Technical Service Bulletin: TSB180058	Released Date: 04-Jun-2018
Belt Noise and Front Engine Accessory Drive Belt Re-routing: Tiffin Recreational Vehicles

Belt Noise and Front Engine Accessory Drive Belt Re-routing: Tiffin Recreational Vehicles

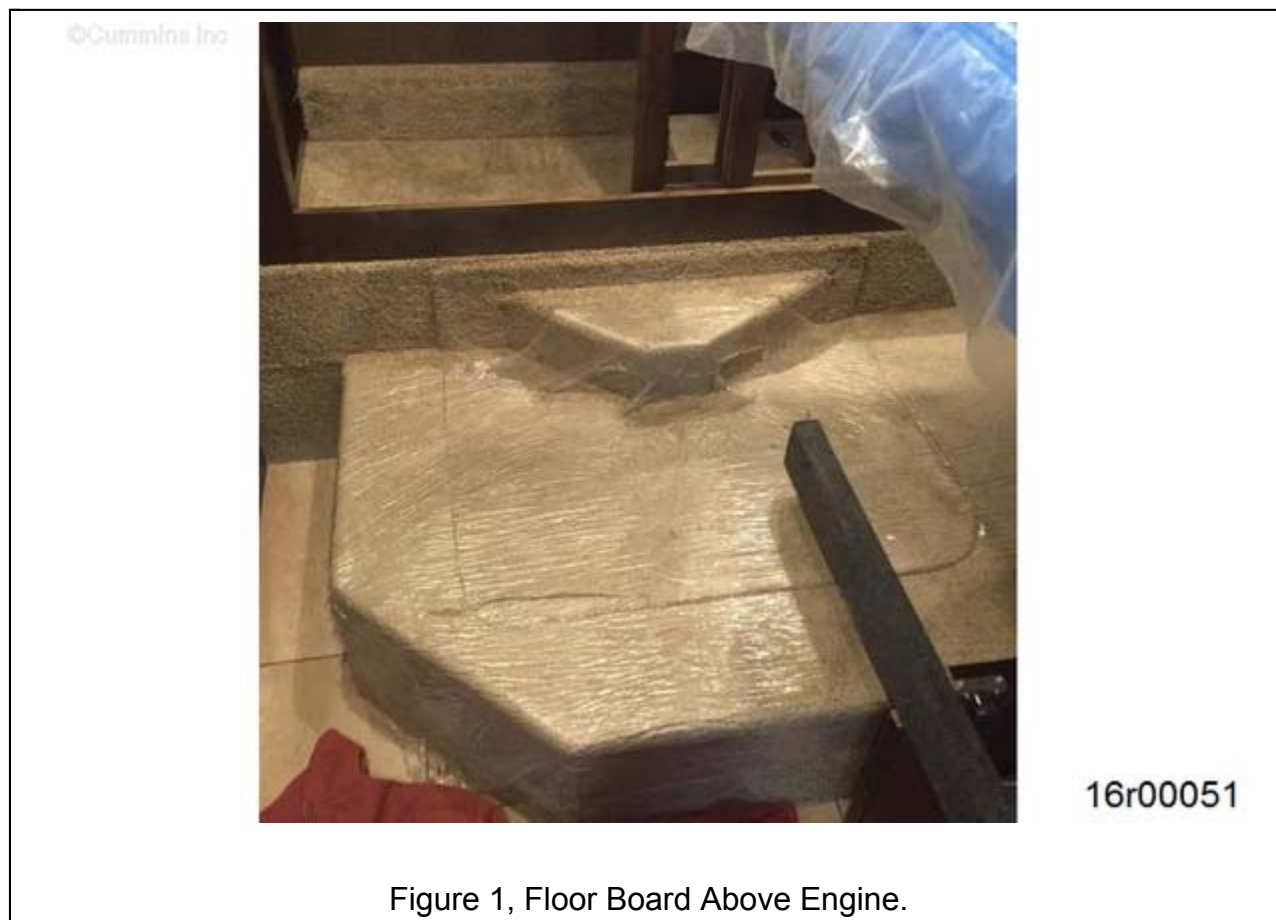
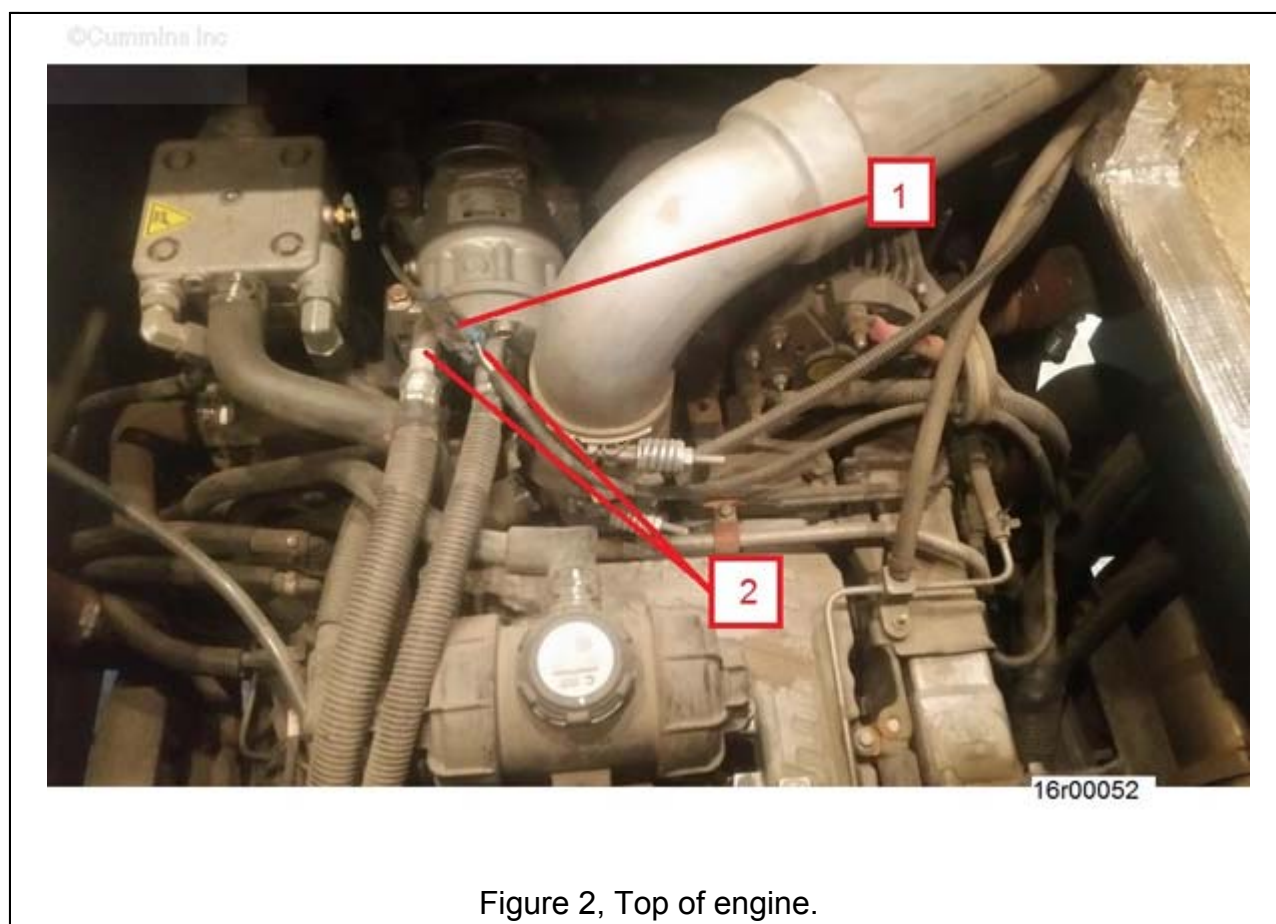
- Belt noise/squeal or belt damage on the secondary belt plane which wraps around the air compressor and the high mount Freon™ compressor.

- Insufficient belt wrap around the air compressor pulley.

- Move Freon™ compressor from high mount to low mount. See Service Instructions section below.
- Modify fan shroud mounting brackets.
- Change belt options to CP80008 and WP80038 for increased belt wrap on plane two belt around the air compressor.

1. OEM Lower Fan Shroud Support Bracket.
2. Lower Idler Pulley.
3. Belts to be removed.
4. Refrigerant Freon™ Compressor.
5. Upper Freon™ Compressor Support.

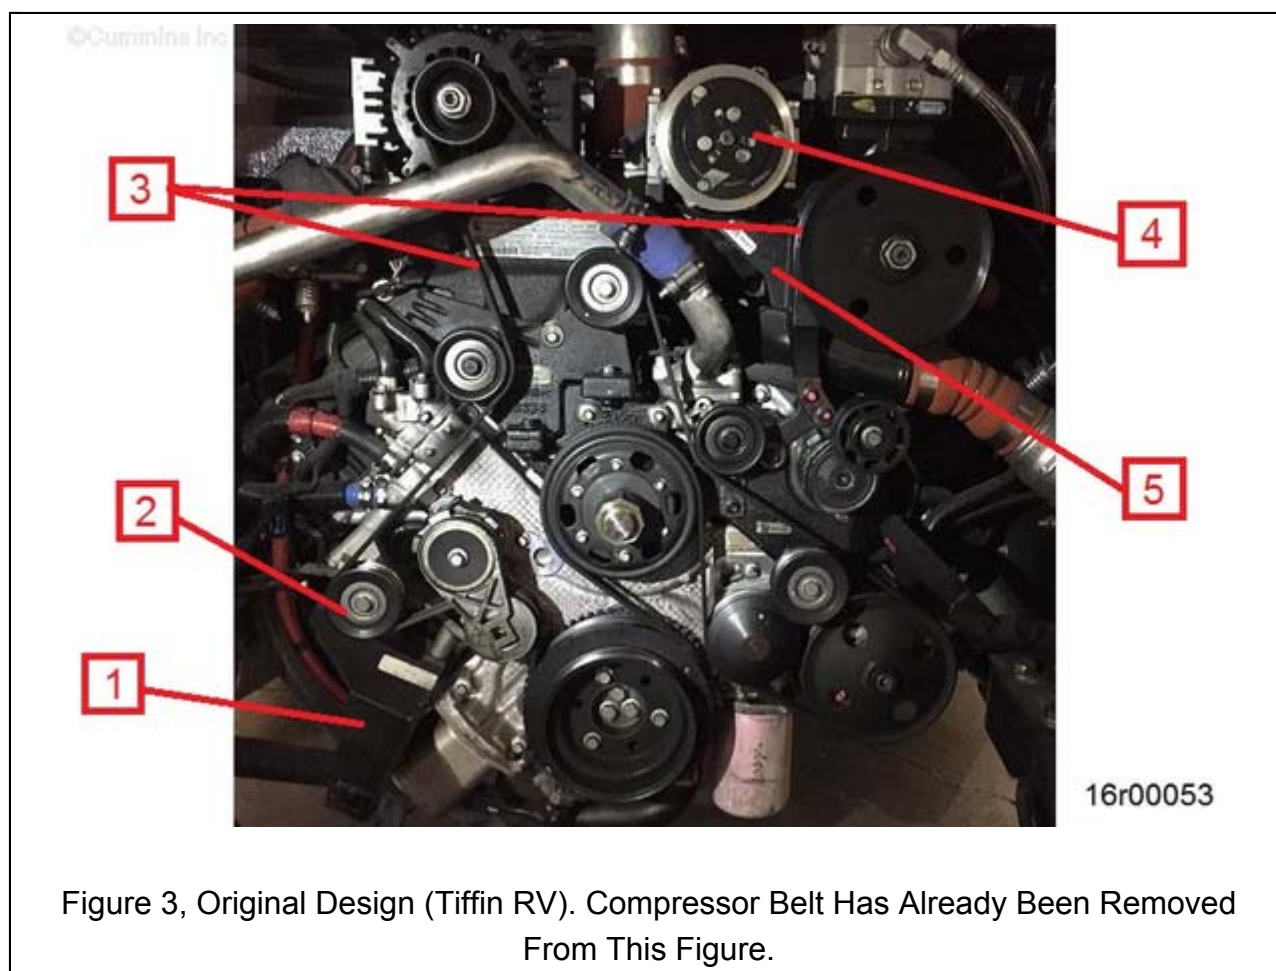
1. Freon™ compressor wiring connector.
2. Freon™ compressor supply/return lines.
4. Remove and discard belts, Part Number: 4335361 and 4335602 (Figure 3).
5. Remove and discard lower idler pulley assembly, Part Number 4390735 (Figure 3).
6. Remove refrigerant Freon™ compressor (Figure 3) from upper refrigerant compressor support.
 - a. Mounted on refrigerant compressor support bracket, Part Number 4360003 (Figure 3).
 - b. Two Sanden Freon™ compressor models have been identified as being used in Tiffin production.
 - i. Model Number U4520 can be reused.
 - ii. Model Number U4897 **must** be replaced due to interference fit in lower position.
 1. Acceptable replacements:
 - a. Model Number U4520
 - b. Model Number U6677
 - c. Model Number U4883

Figure 4, Lower Accessory Drive Mounting with L-Bracket and P-Clamp.

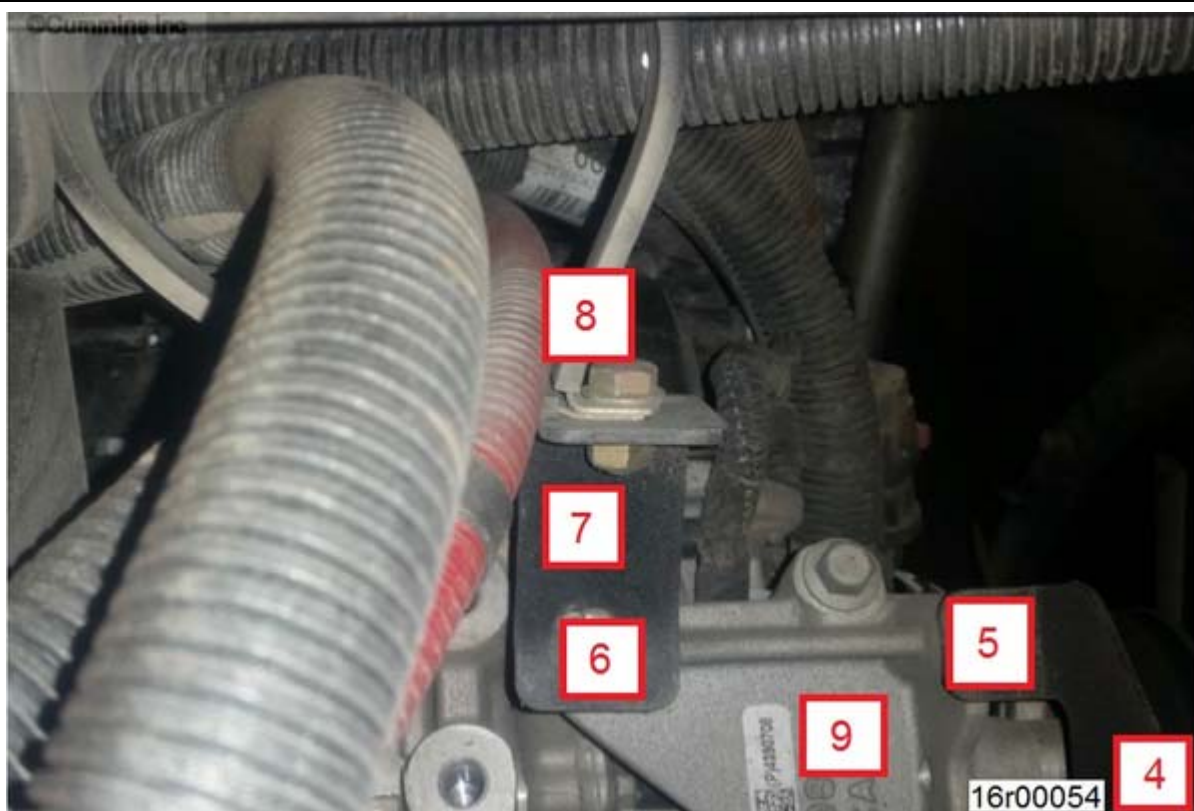
7. Remove L-Bracket (Figure 4 - 7) and P-clamp (Figure 4 - 8) assembly from lower accessory support, Part Number 4390708 (Figure 4 - 9).

8. Remove OEM lower fan shroud support bracket (Figure 4 - 4) mounted to lower accessory support bracket, Part Number 4390708, (Figure 4 - 9) and OEM fan shroud.

- a. Discard OEM supplied cap screws which mounts the lower accessory support bracket to the engine. (Figure 4 - 5 and Figure 4 - 6).
- b. Install new OEM lower fan shroud support bracket (Figure 4 - 4) using new cap screws, washers, and nut at fan shroud position. (Figure 4)
- c. Reuse L-bracket (Figure 4 - 7) and P-Clamp assembly (Figure 4 - 8)
- d. Tighten all fasteners to proper specifications. See equipment manufacturer service information.

9. Install Sanden Freon™ compressor on lower accessory support, Part Number 4390708 (Figure 4 - 9).

- a. Do **not** tighten capscrews at this time.
- b. Reuse two of the OEM supplied freon compressor mounting bolts from upper mount configuration. (capscrews M8 x 80mm x 1.25)
- c. Install first capscrew in the lower mounting hole towards the rear of the engine.
- d. Install second capscrew (Figure 4 - 6) through the L-bracket and P-clamp assembly (Figure 4 - 8) in upper mounting hole towards the rear of the engine.

Figure 5, Freon™ Compression Lower Mount Option With Spacers Installed on Fan Shroud Support Bracket.

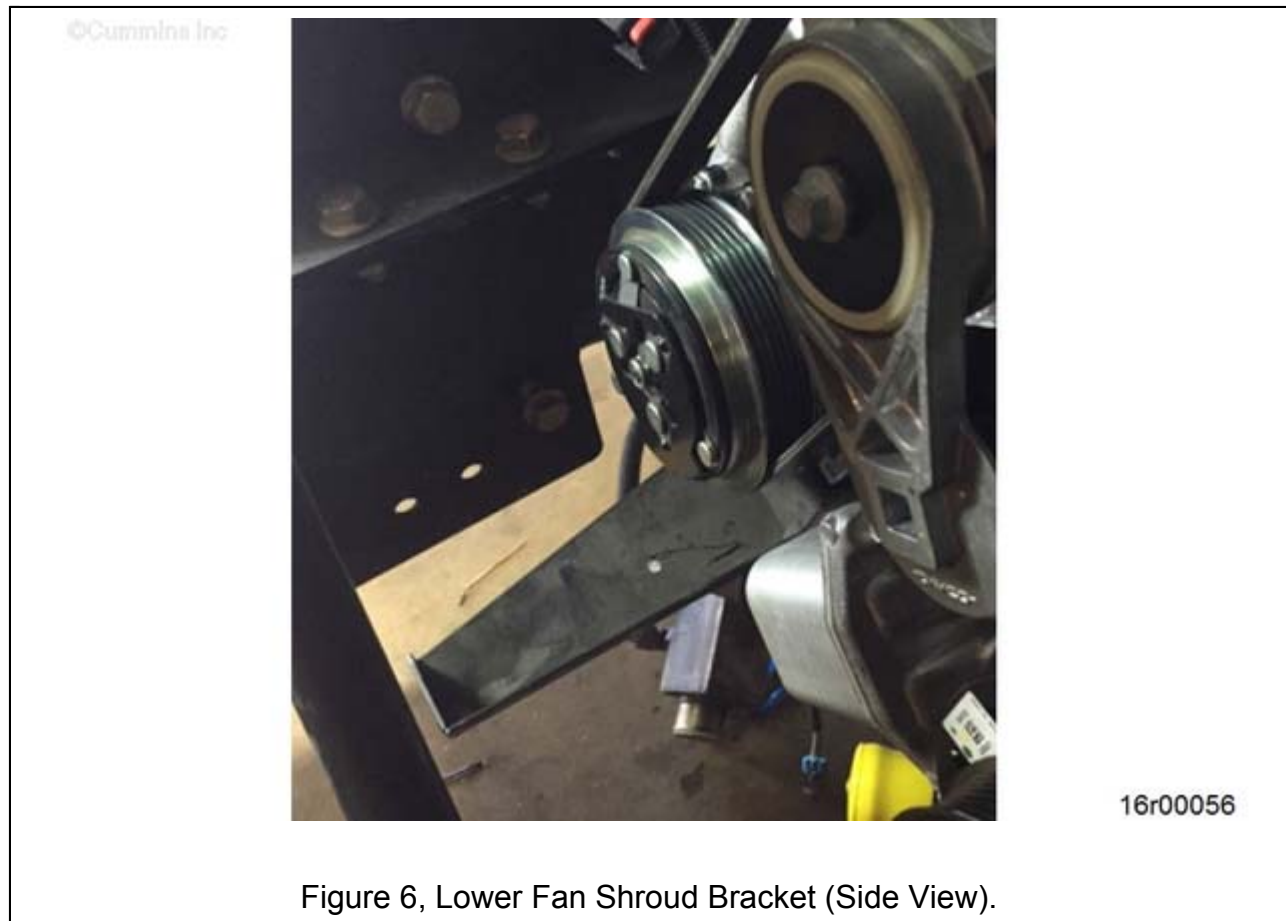
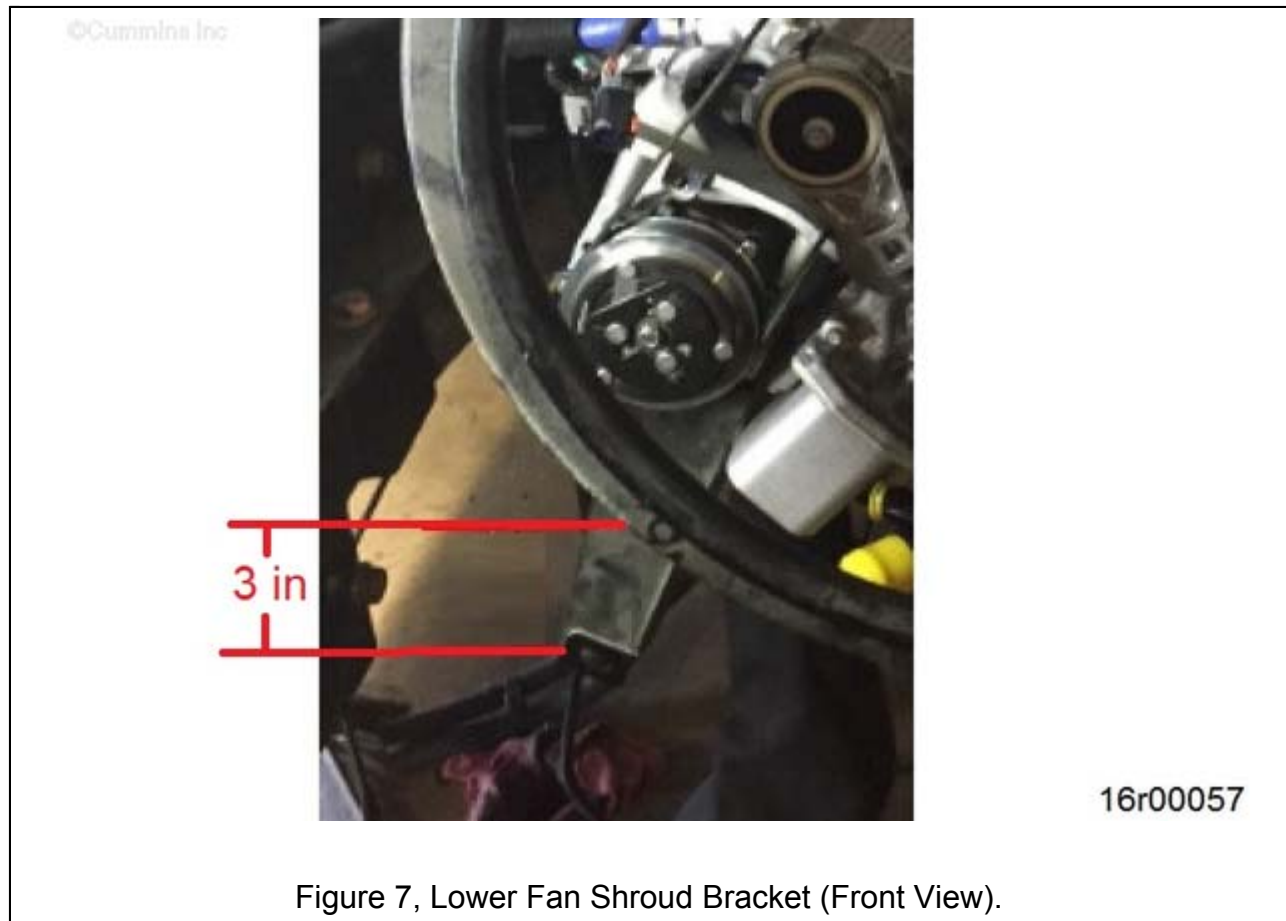
Fabricate lower fan support bracket (if needed) (Figure 5 - 3).

11. Install 12.5 mm [½ in] spacers (Figure 5 - 1) between bracket and Freon™ compressor body with two new mounting capscrews (M8 x 120mm x 1.25) (Figure 5 - 2) in remaining holes. (12.5 mm [½ in] spacers allow for access to belt).

- a. Align refrigerant Freon™ compressor drive pulley and tighten refrigerant Freon compressor mounting capscrews to specifications.
- b. 12.5 mm [½ in] spacer can be manufactured or sourced. Fabricated with 9.5mm [3/8] ID x 12.5 mm [½ in] long in black pipe. Paint spacers black before installing.

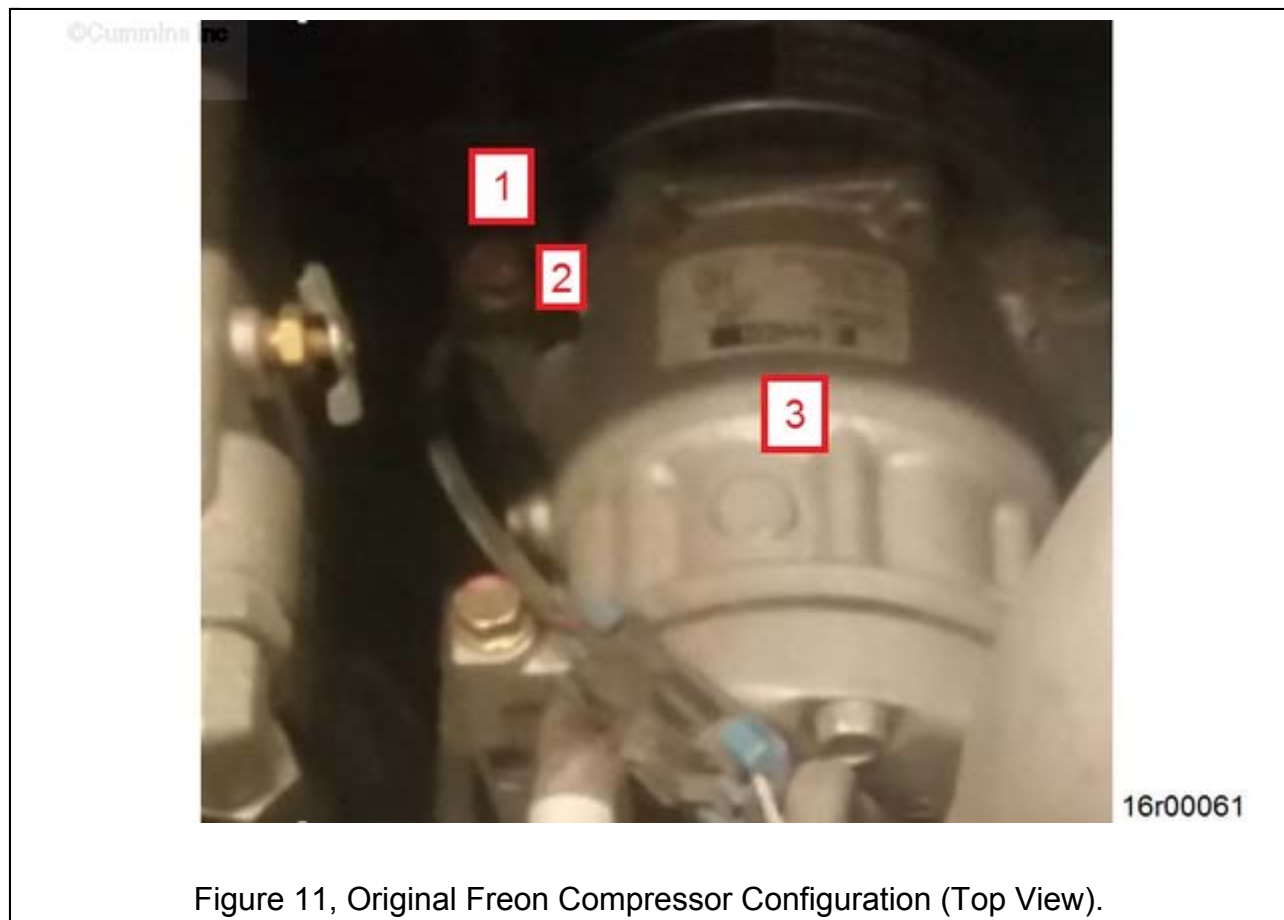
15. Fan Shroud upper support bracket (Figure 10 – 1 & 11 – 1) originally mounted with refrigerant Freon™ compressor mounting capscrew (Figure 11 - 2). With refrigerant Freon™ compressor (Figure 11 - 3) no longer in the upper location, a spacer needs to be installed. Spacer can be sourced or fabricated.

- a. Fabricated with 9.5mm [3/8] ID x 75 mm [3 in] long black pipe.
- b. Install spacer (Figure 10 - 3) in place of Freon™ compressor in upper OEM fan shroud support. Reuse 1 of original Freon™ compressor mounting capscrews. M8 x 80mm x 1.25 (Figure 10 – 2).
- c. Paint spacer before installing
- d. Tighten all fasteners to proper specifications.
